SUBJECT: MAYPORT DOCKS REDEVELOPMENT PROJECT- REBID

SUBJECT: Change Order #4 BID# CP-0137-21 Contract 71479-22/ PO 633930-22
Shoreline Foundation, Inc.
Mayport Dock Redevelopment

CITY OF JACKSONVILLE
DEPARTMENT OF PUBLIC WORKS
ENGINEERING DIVISION
CONSTRUCTION CHANGE ORDER

Subject: **RCO #06-Flowable Fill, Rip Rap, Fencing, Gates and Bollards**

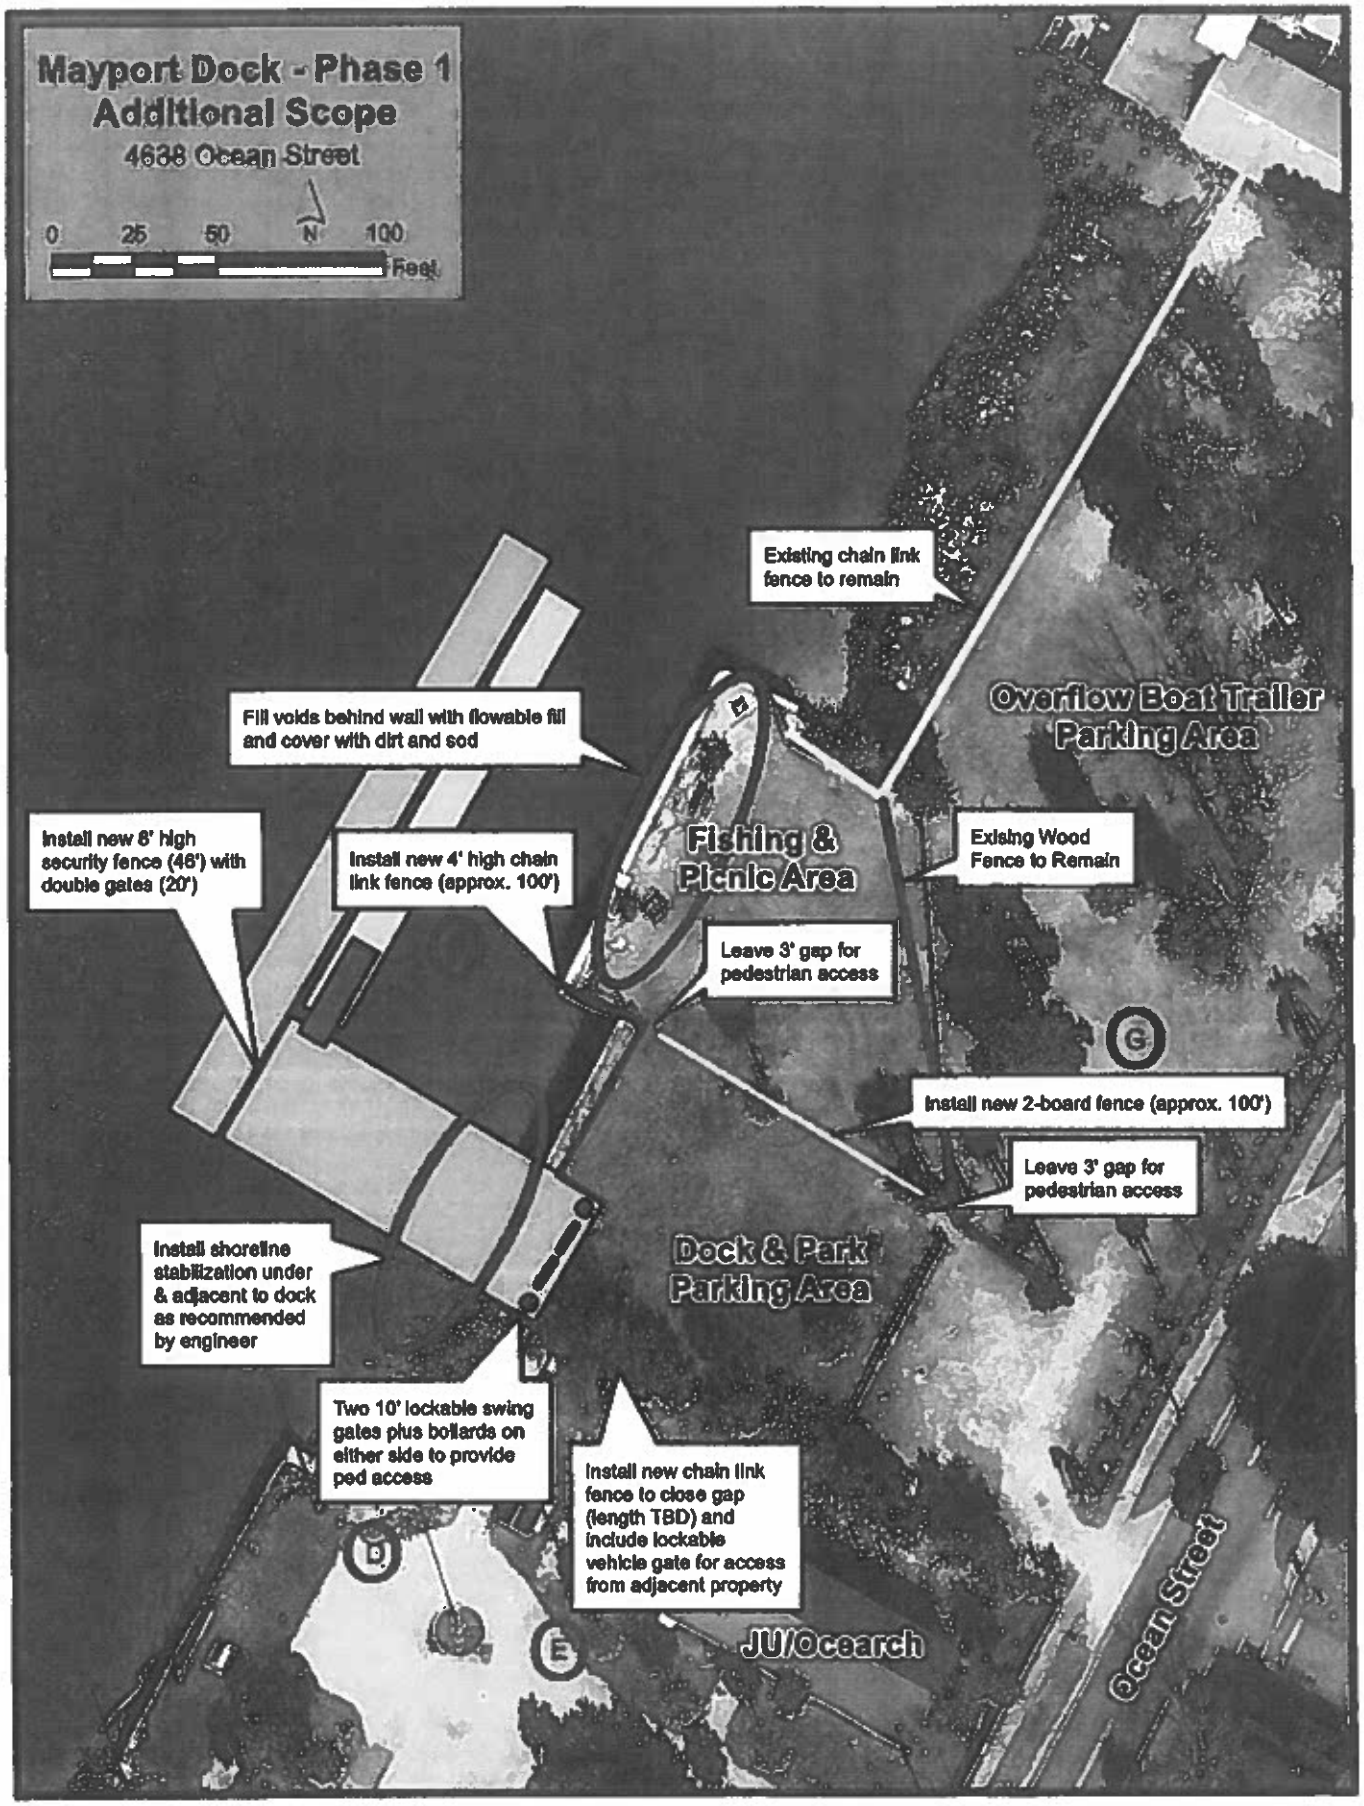
Shoreline Foundation, Inc. (SFI) is providing this Request for Change Order (R.C.O.) for the additional work being requested by City of Jacksonville (COJ) via email dated May 18, 2023. The COJ email included the attached google photo with PDF markups, upon which SFI has identified as items "A" thru "G" for pricing purposes.

Item "A" labeled "Fill voids behind wall with flowable fill and cover with dirt & sod":
Flowable fill covered with clean fill material and sod. We have accounted for up to 40 cy of flowable fill. Any additional flowable fill required will be billed separately. The flowable fill shall be installed with a concrete pump in one (1) pour. Following, the area shall be finished with 4" thick dirt fill up to 54 CY, and topped with up to 3375 SF of Bahia sod.

Item "B" labeled "Install new 8' high security fence (46') with double gates (20')":
This scope of work shall include approximately 46' of 8' high industrial grade aluminum fencing to be install on the pier deck surface, as outlined in the attached Armstrong's Fencing proposal. The swing gates shall be 8' high, matching the fence height, and includes two (2) 10' wide swing gates (aka. 20' wide double gate) with 2.5" posts, 1" pickets and black in color. Posts shall be connected to the pier deck surface with concrete anchors. The fencing and gates are priced as a typical fencing/gates' details with no specific additional security features or reinforcing as none were provided.

Item "D" labeled "Two 10' lockable swing gates plus bollards on either side to provide ped access":
This scope of work shall include two (2) 10' wide swing gates (aka. 20' wide double gate) with 2.5" posts, 1" pickets and black in color, as outlined in the attached Armstrong's Fencing proposal. The gates are priced as a typical gates' details with no specific additional security features or reinforcing as none were provided. Posts shall be connected to the pier deck surface with concrete anchors. Two (2) 4" diameter bollards shall be connected to the pier surface with concrete anchors, and shall be concrete infilled with Quikrete 4,000 psi concrete, or approved bagged concrete.

Item "E" labeled "Install new chain link fence to close gap (approx. 80') and include lockable vehicle gate for access from adjacent property":
This scope of work shall include 80' of 6' high galvanized chain link fence with one (1) 10' wide lockable vehicular gate along the south property line, as outlined in the attached Armstrong's Fencing proposal. The fence & gates are priced as a typical fence/gates' details with no specific additional security features or reinforcing as none were provided.

Item "F" labeled "Install new 4' high chain link fence (approx. 100')":
This scope of work shall include 100' of 4' high galvanized chain link fence, as outlined in the attached Armstrong's Fencing proposal. The fence is priced as a typical fence detail with no specific additional security features or reinforcing as none were provided.

Item "G" labeled "Install new 2-board fence (approx. 100')":
This scope of work shall include 100' of 4' high 2-board wood fence, as outlined in the attached Armstrong's Fencing proposal. The fence is priced as a typical fence detail with no specific additional security features or reinforcing as none were provided.

JUSTIFICATION: Pre Parks request this is for providing fencing, gates and bollards to control access to the dock, flowable fill with dirt and sod on top for areas with voids and compacted millings for the ramp onto the dock for a more durable entrance.
